SUBJECT: RM Fan Housing Bolt Torque

NUMBER: SB-0243

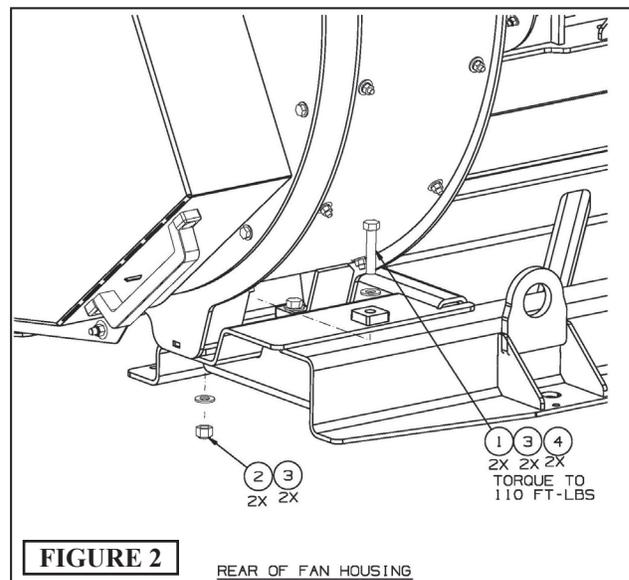
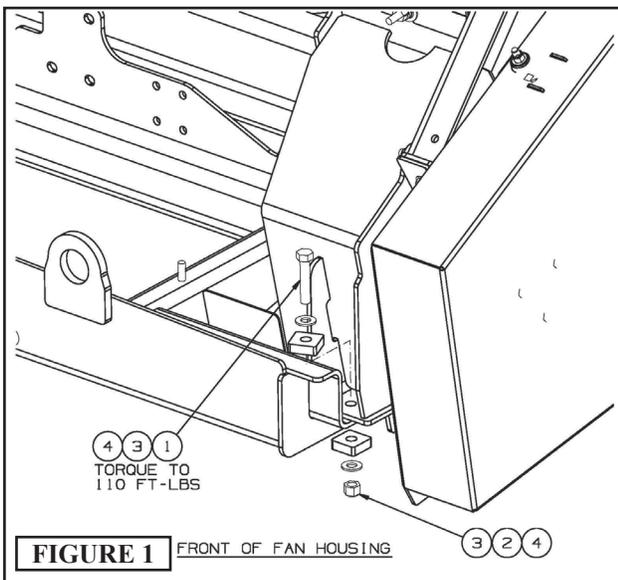
FSO 1140232 provides parts and instructions to update the Fan Housing Assembly Retention. Grade 5 hardware is replaced with new Grade 8 hardware and new spacers must be installed. Bolts must be tightened to 110 lb-ft.

1. Order FSO 1140232 for all affected units.
2. Install FSO 1140232 as instructed in the drawing supplied with the kit. (reference FIGURES 1&2)

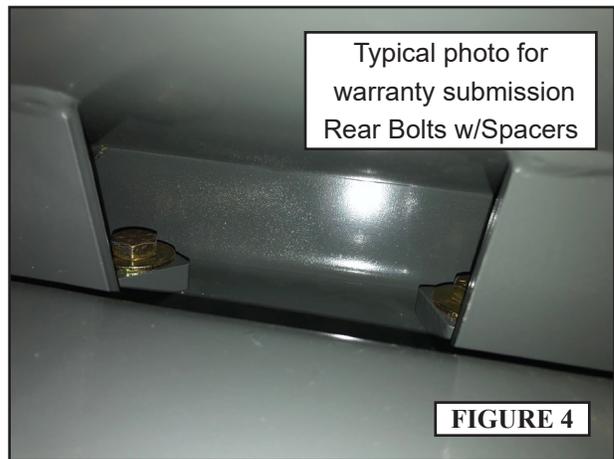
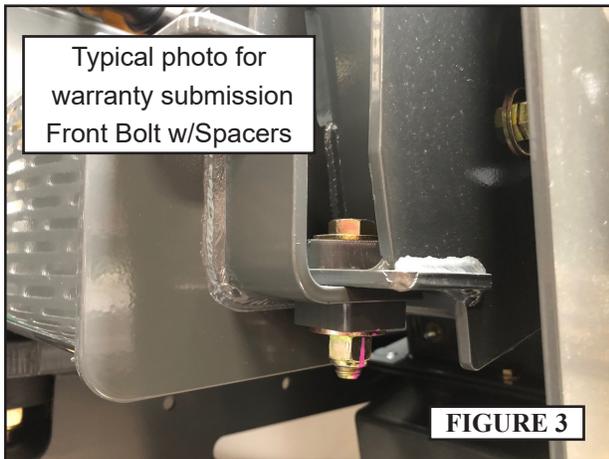
Submission must include photo of the completed installation for each unit. See typical photos (FIGURES 3 and 4).
